Exhibits amended by Staff 6-22-92
CITY PLANNING COMMISSION
 1231 "I" STREET, SUITE 200, SACRAMENTO, CA 95814

- APPLICATION:**
- A. Variance to reduce the required side yard setback from five feet to two feet on 1.03± developed acres in the Multi-Family (R-3) zone.
 - B. Variance to reduce the required distance between an accessory structure and a main structure from six feet to five feet.

PROPOSAL: The applicant is requesting the necessary entitlements to construct a carport over existing uncovered parking for an existing 32 unit apartment complex.

APPLC. NO. P92-117

**EXHIBIT - A
REVISED**

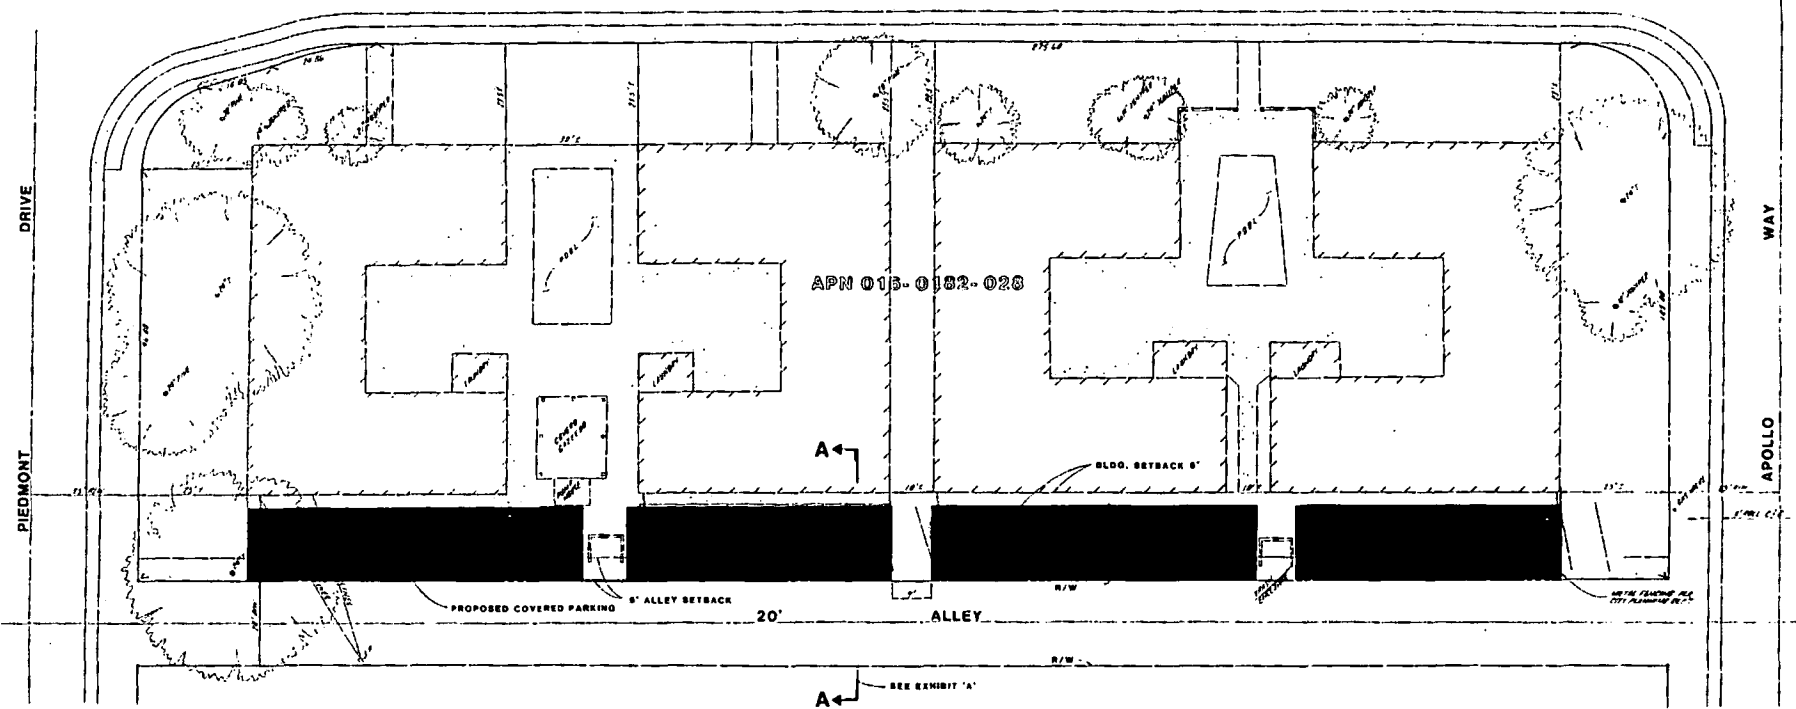
The site plan indicates the carport will extend into the rear setback to cover a space located in that area. Staff recommends the carport structure not extend into the rear setback area along Apollo Way. Additionally, the proposed site plan indicates only 30 parking spaces. Staff recommends the site plan be redesigned to meet the requirement of 32 parking spaces. Compact parking spaces may be utilized to meet the parking space requirement.

- 1. The applicant shall redesign the carport structure so it does not extend into the rear setback area. The applicant shall submit revised site plans for Planning Director review and approval prior to the issuance of building permits.
- 2. The site parking plan shall be redesigned to meet the requirement of 32 parking spaces which meet Zoning Ordinance requirements for size and maneuvering and the revised plan shall be submitted for Planning Director review and approval prior to the issuance of building permits.
- 3. The applicant shall construct a metal lattice, painted to match or accent the existing building, on each end of the carport and revised elevations shall be submitted for Planning Director review and approval prior to the issuance of building permits.

TYPICAL CROSS SECTION ○

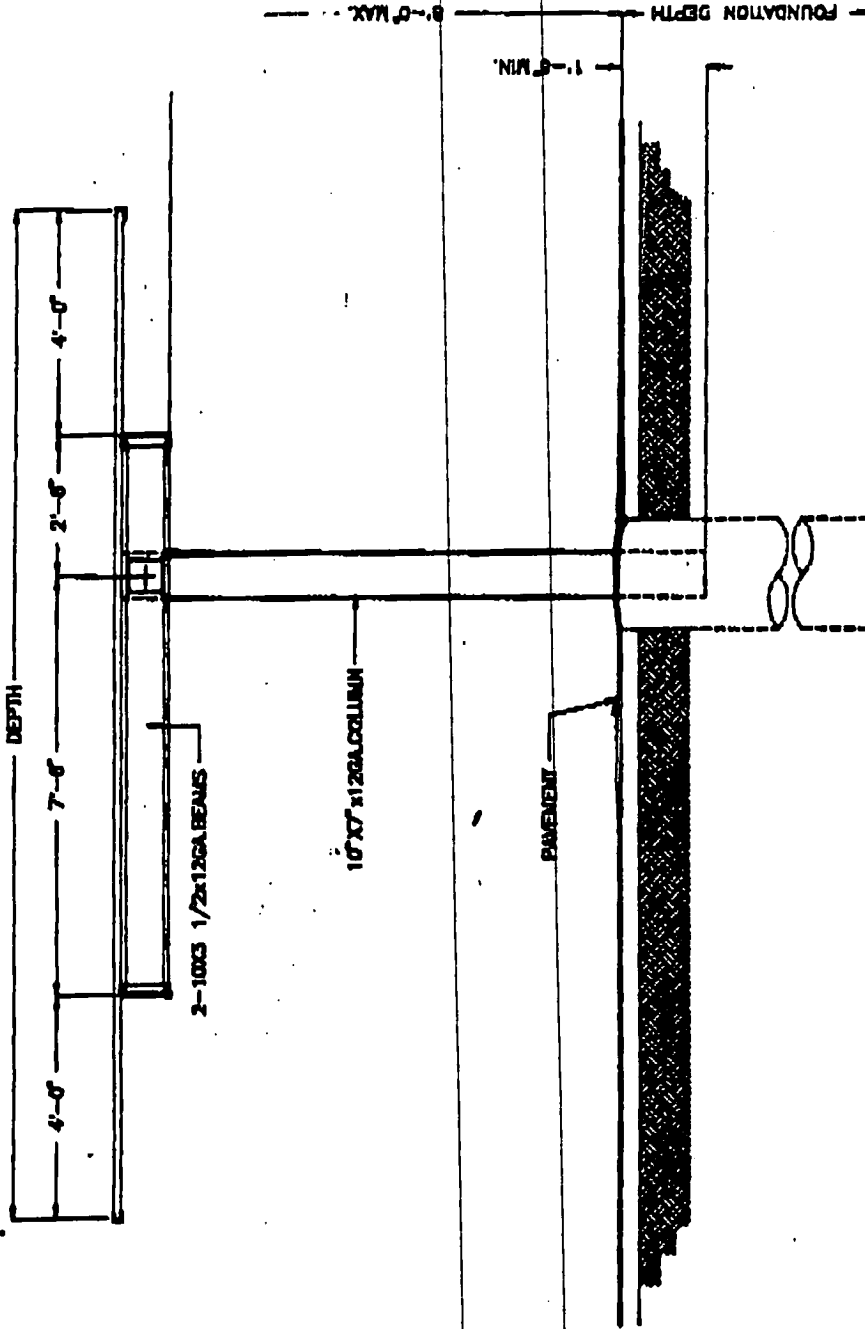
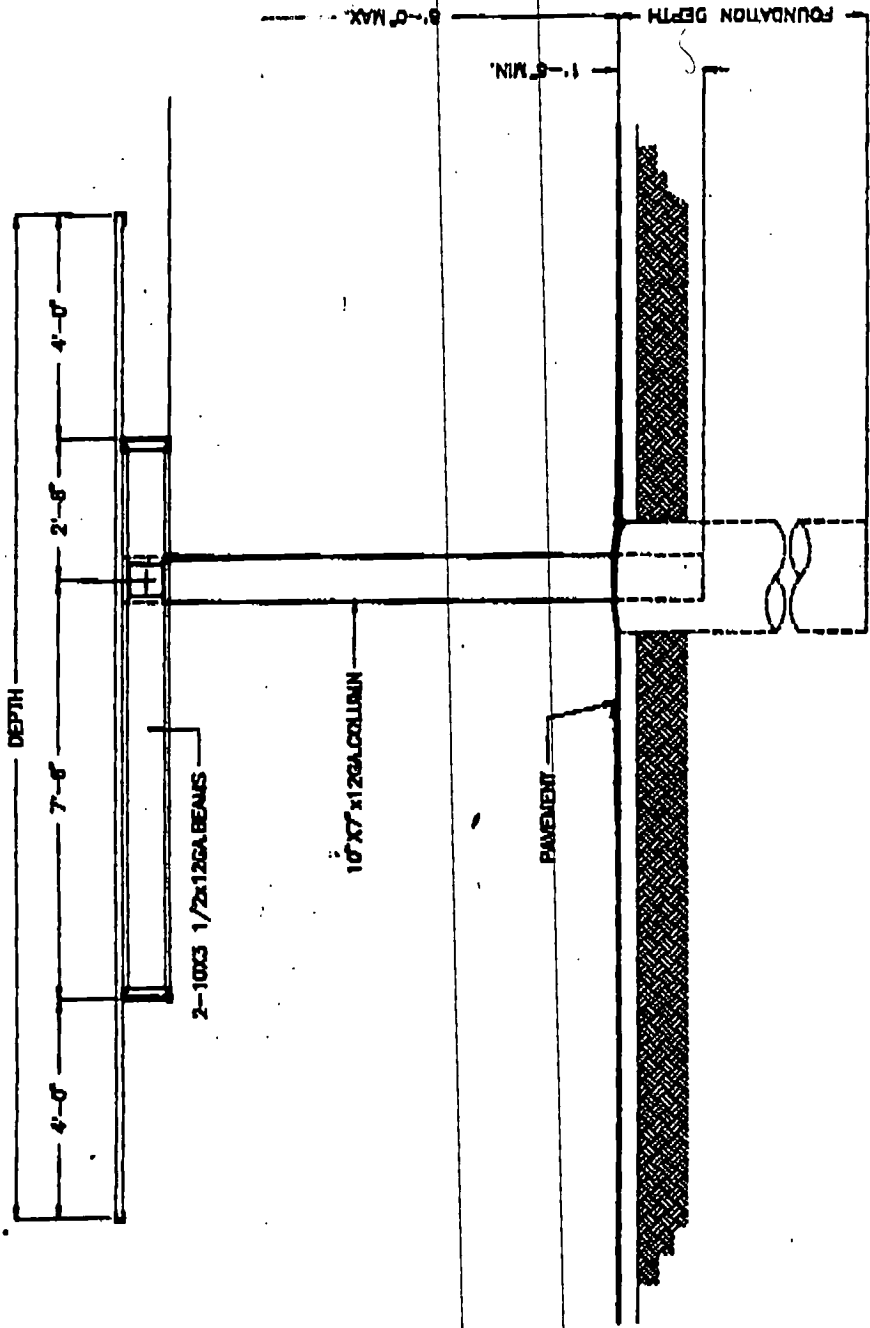
The applicant is proposing to construct the carport with metal posts and a metal roof (see

Exhibit B). Staff recommends a metal lattice, painted to match or accent the existing building, be constructed on each end of the carport to help screen the parking area from each street side and the surrounding residential uses.
